la marzocco USA technical bulletin 201

New gateway on Linea PB and KB90

November 16, 2025

E.4.456 - WIFI BOARD S3

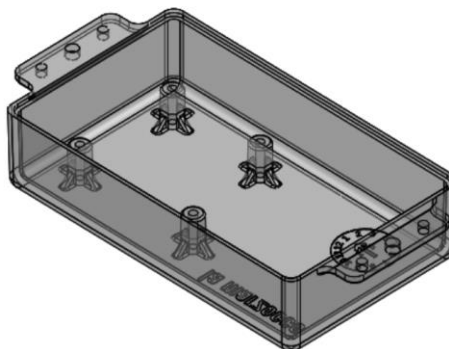
We are pleased to inform you of a new gateway in production for Linea PB and KB90 machines. The current gateway (P/N: E.8.006.03) will be replaced with a new gateway that no longer requires an external antenna. The new gateway will be installed in the same position as the existing one, under the frame.

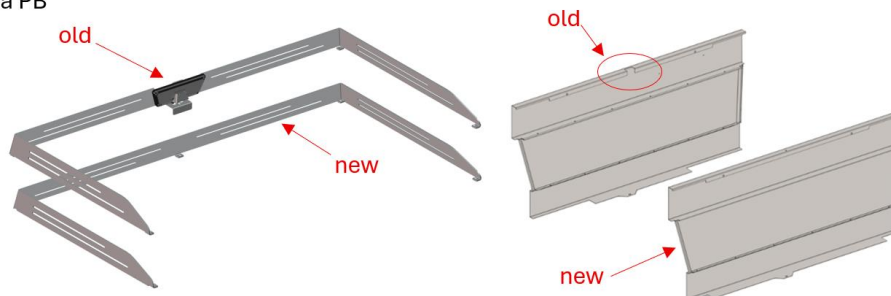
All Linea PB machines starting from the serial numbers below have the new gateway:

- 2GR: PB054683
- 3GR: PB055228
- 4GR: PB057023

Linea PB

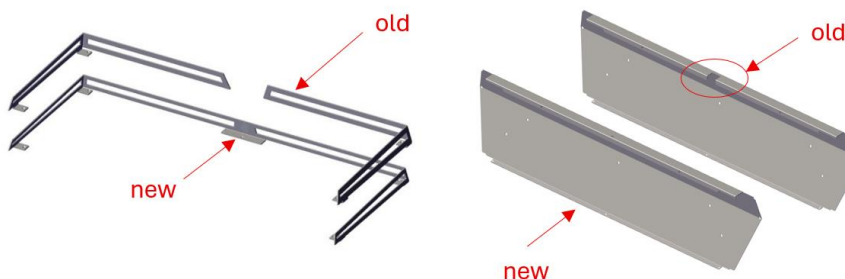
New machines will now feature the one-piece cup rail and a back panel without the antenna slot. This back panel will be polished (KB90) or have a brushed finish (Linea PB).
